NOTICE OF MEETING

City of Ryde Local Planning Panel Meeting No. 7/19

DA Number	LDA2018/0385
Site Address & Ward	8 Grove Lane, Eastwood West Ward
Zoning	R2 Low Density Residential
Proposal	New multi-dwelling housing development comprising 3 x two storey 3 bedroom dwellings, 1.0m high front fence, associated car parking and tree removal.
Property Owner	Xiao Chun Yan
Applicant	Steve Wu
Report Author	Hussein Bazzi – Assessment Officer
Lodgement Date	4 October 2018
No. of Submissions	Twenty – seven (27) submissions objecting to the development. Seven (7) submissions to the amended plans.
Cost of Works	\$955,350.00
Reason for Referral to LPP	Contentious Development – Development is the subject of 10 or more unique submissions by way of objection

Figure 13 Shadow diagram exert Sheet 06 of 17 submitted by SETT Homes

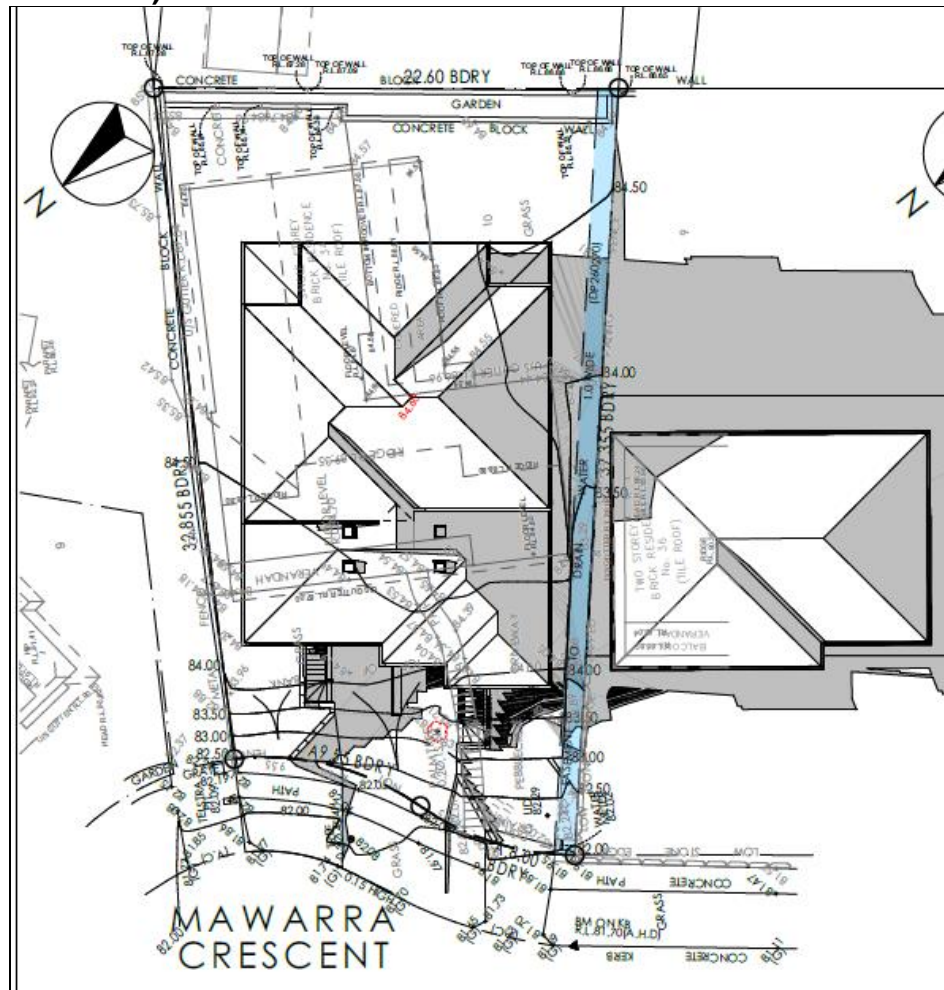
The original determined raised concerns with compliant solar access not being demonstrated and the shadow impact upon the neighbouring property. Control (c) requires windows to north facing living areas of subject dwelling to receive at least 3 hours sunlight between 9am and 3pm on 21 June. The submitted shadow diagrams, shown in **Figure 13** have not adequately demonstrated compliant solar access is achieved to the proposed dwellings. The information for example does not take into consideration the shadow which will impact the proposed dwellings from the adjoining properties to the north. The supporting planning assessment prepared by Ingham Planning Pty Ltd indicates *the proposed dual occupancy dwellings receive morning solar access to the rear family rooms for almost 2 hours in mid-winter from 9am to 10:45am and receive in excess of 2 hours solar access to the front lounge rooms in the afternoon in mid winter.*

Figure 14 Elevation shadow diagram Sheet 07 of 17 prepared by SETT Homes

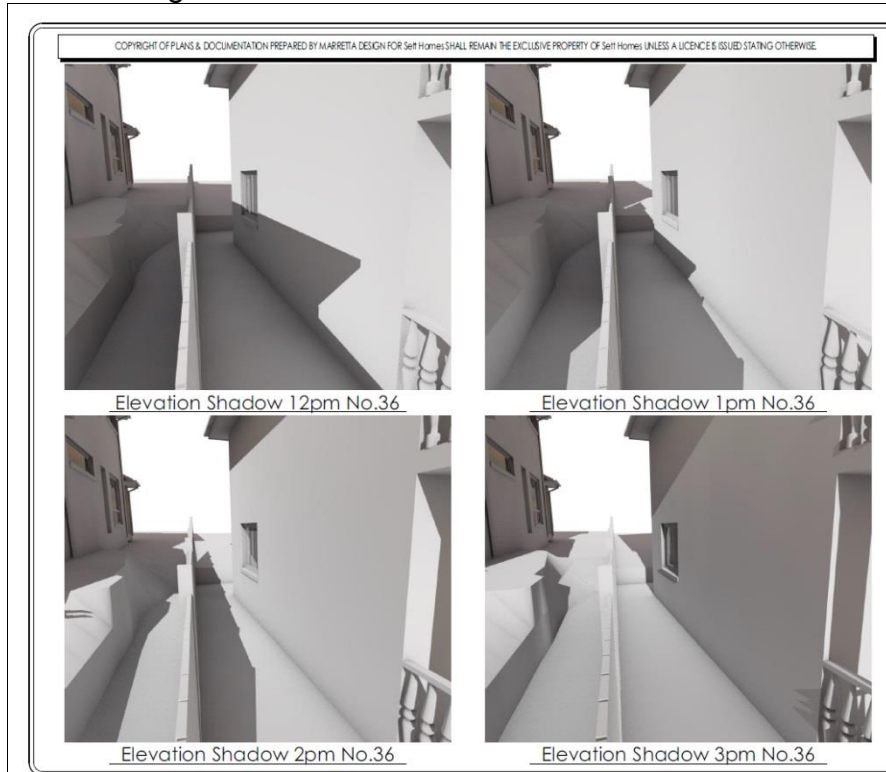
(e)(ii). The proposal has not demonstrate appropriate solar access to provided to the proposed dwellings and maintained to the neighbouring property at 36 Mawarra Crescent. It is considered likely, the proposal could demonstrated compliance with control (e)(ii) but the information submitted has not achieved this. The proposal is unacceptable in this regard.

Comment: The proposal does result in overshadowing of the living room window. The applicant has submitted further elevational shadow diagrams (**Figure 14**) which indicate sunlight is provided to this window between 12 noon and the Applicant indicates until 3pm. This is not agreed to. As the proposal results in a partial impact at 12 noon, the extent is not known by the level of information submitted and the window does not receive direct sunlight at 3pm. However, it is considered this opening is likely to receive partial sunlight between 11:30am and 2:30pm and would meet the control requirement.

Figure 10: Side (South) Elevation comparison of the approved garage and the amended carport. This image demonstrates both the reduction in height of 1.88m and the maintained reversing sightlines

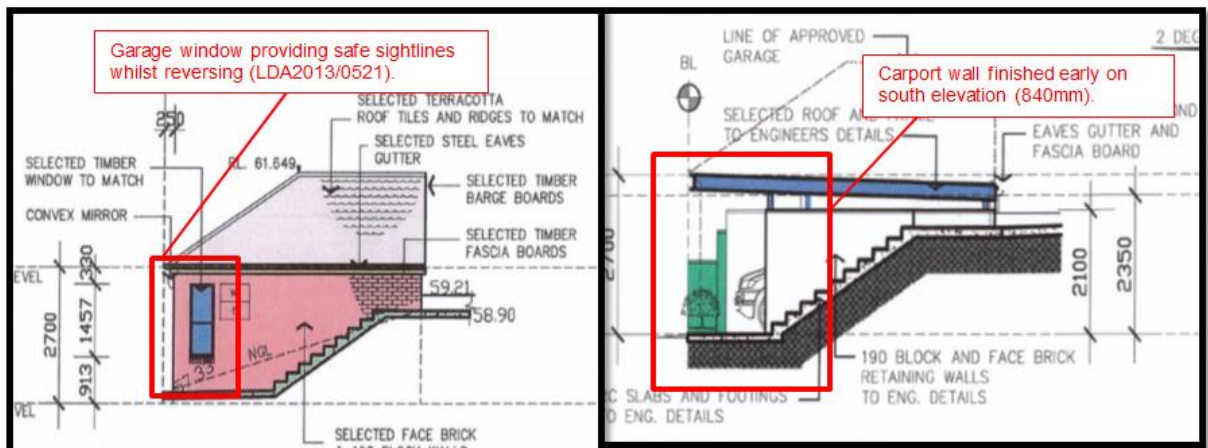
As shown in the above **Figure 10** Condition 1(a) ‘Access & Parking’ has been satisfied by the additional setback nature of the southern portion of the carport. The above condition is no longer necessary and can be deleted from the consent.
